Re: Edwards Aquifer, Comal County
NAME OF PROJECT: Kirkwood Manor; Located at the intersection of Loop 337 and Walnut Avenue; New Braunfels, Texas
TYPE OF PLAN: Request for a Modification of an Approved Water Pollution Abatement Plan (WPAP); 30 Texas Administrative Code (TAC) Chapter 213 Edwards Aquifer
Edwards Aquifer Protection Program ID No. 1281.03; Investigation No. 722948; Regulated Entity No. RN102751195

Re: Edwards Aquifer, Comal County
PROJECT NAME: Kirkwood Manor, located at 2590 Loop 337, New Braunfels, Texas
PLAN TYPE: Application for Approval of a Water Pollution Abatement Plan (WPAP) 30 Texas
Administration Code (TAC) Chapter 213; Edwards Aquifer Protection Program
EAPP File No.: 1281.03

Re: Edwards Aquifer, Comal County
Kirkwood Manor, Modification of Approved WPAP, dated 12/19/2008
Response to first review comments dated February 17, 2009

CONSTRUCTION OF
CELL TOWER
WITH CONSTRUCTION
OF NEW ADDITON

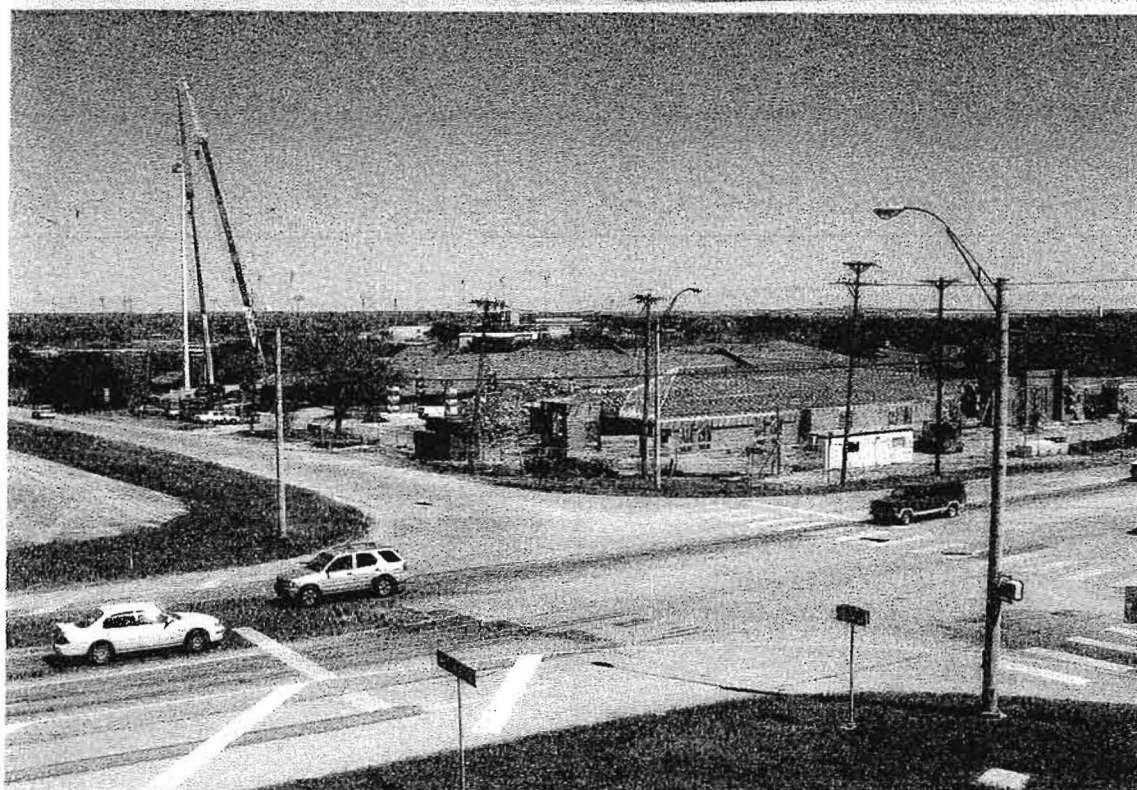
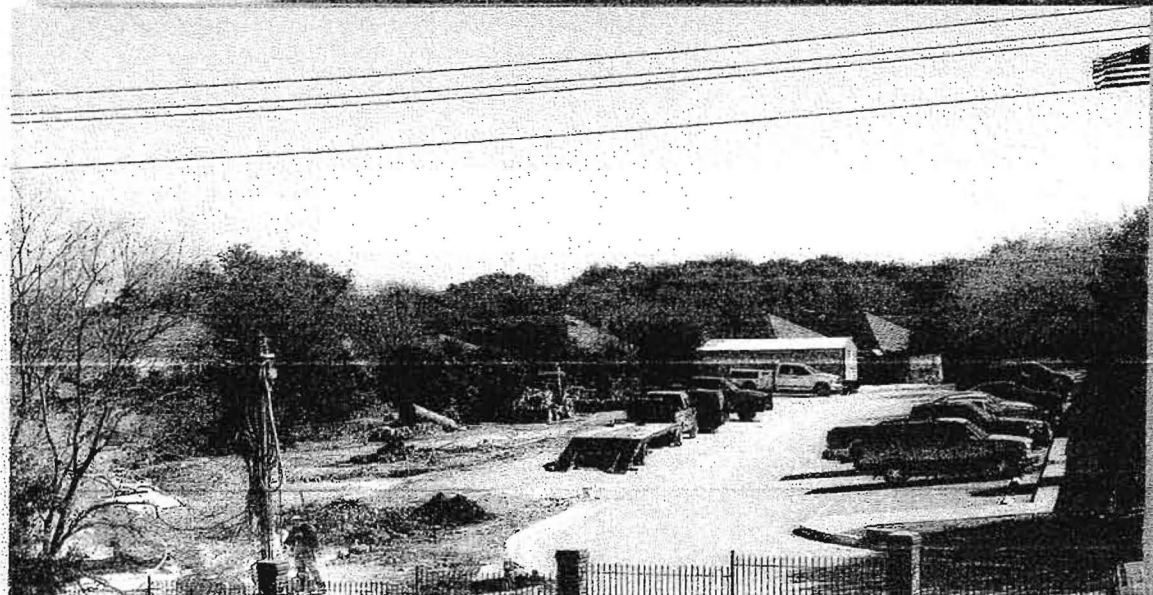
- a. The cell tower and equipment located by BMP do not appear to be a part of any application previously submitted for the site. Please explain and provide any supporting documentation.

The cell tower was not shown on the site plan of the original WPAP, but was constructed at the same time as the nursing facility addition. Attached photos show it under construction at the same time as the nursing facility addition. The area for the cell tower was included in the original WPAP impervious cover of 3.455 under Structure and Rooftop, as shown in TCEQ Form 0584 is 70,567 sf. The main building rooftop is approximately 69,000 square feet as measured from an aerial dated 2008 obtained from Comal GIS at 6-inch resolution (the main building rooftop as measured from the architect CAD file is 67,500), the storage building is approximately 750 sf (from survey), the gazebo is approximately 230 sf (from survey), the cell tower 680 sf (as taken from cell tower plans) for a total of 70,660 sf. The difference, approximately 93 sf or 0.002 acres, is minor and can be attributed to the resolution of the aerial imagery.

BMP1- VALVE

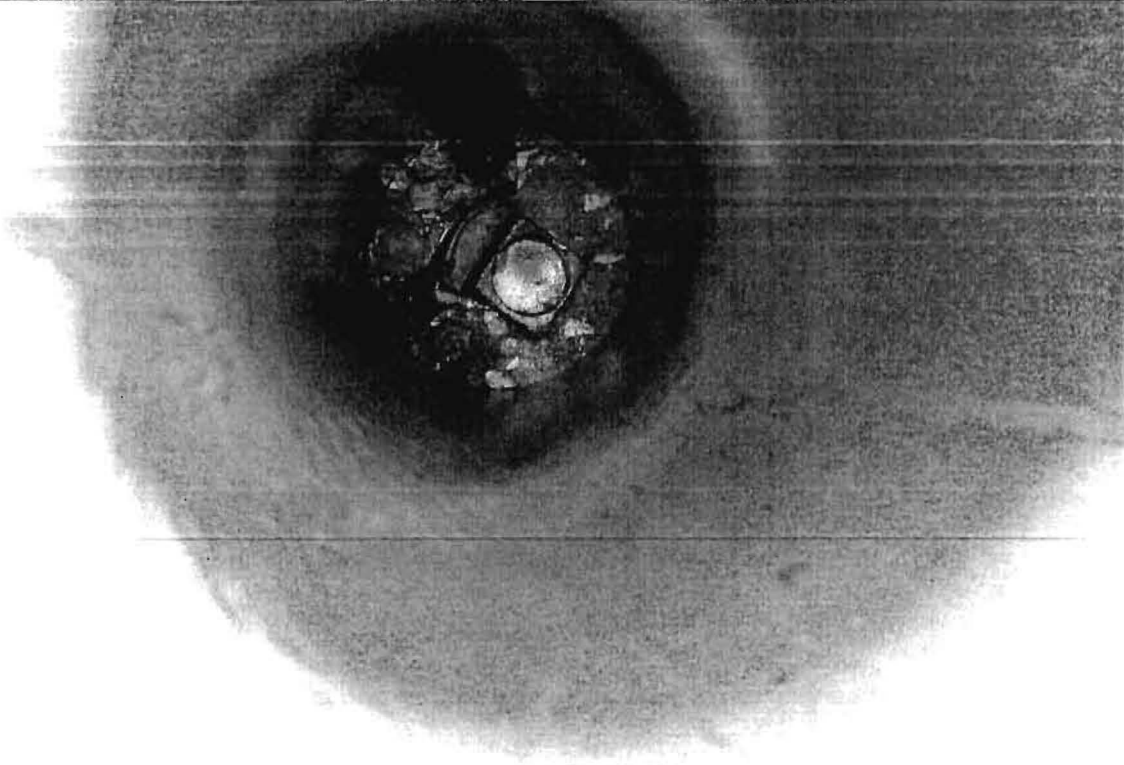
- b. The gate valves for both BMPs appear to be inaccessible due to large amounts of debris on top of the valves. Please maintain the access points so the valves are accessible and provide supporting photographic documentation of the maintenance.

- Pictures of valves of BMP1 and BMP2 free of debris
- Pictures of restored outfall for BMP 2, letter from facility manager attesting to functionality of drain.
